UNITED STATES PATENT AND TRADEMARK OFFICE

APPLICATION NO.	FILING DATE	FIRST NAMED INVENTOR	ATTORNEY DOCKET NO.	CONFIRMATION NO.
09/659,172	09/11/2000	Ted A. Lilley	3835.00002	6251

Office Action Summary

In regards to claim 1, in figure 4 below,

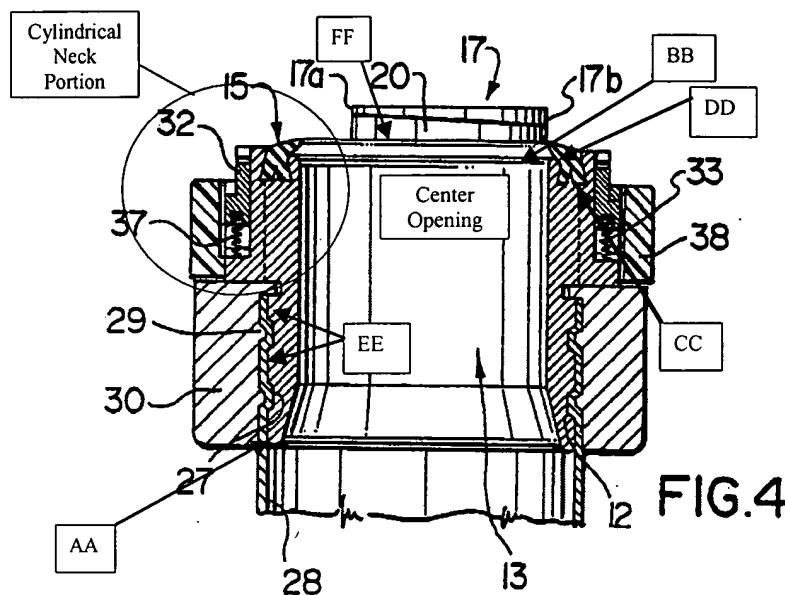
Claims 1-3 and 7-9 are rejected under 35 U.S.C. 102(b) as being anticipated by US patent 5333915, Sparling et al.

Sparling et al discloses a

hydrant nozzle comprising a tubular body portion (12) extending longitudinally between a first end (AA) and a second end (BB), the body portion having a generally cylindrical outer surface and a generally cylindrical inner surface defining a fluid passageway (13) between the first and second ends, a cylindrical neck portion extending from the second end of the body portion to a front face (16) and having an outer peripheral rim (CC) and an inner rim (DD) defining a center opening in fluid communication with the fluid passageway of the body portion; a pair of spaced apart locking lugs (EE) projecting outwardly from the outer surface and positioned between the first and second ends of the body portion; and a pair of spaced apart arcuate shaped locking grooves (20) recessed in the front face of the neck portion.

In regards to claim 2, Sparling et al discloses each of the locking grooves being defined by a bottom surface (FF) recessed from the front face of the neck portion and extending between spaced apart first and second end walls defining the grooves.
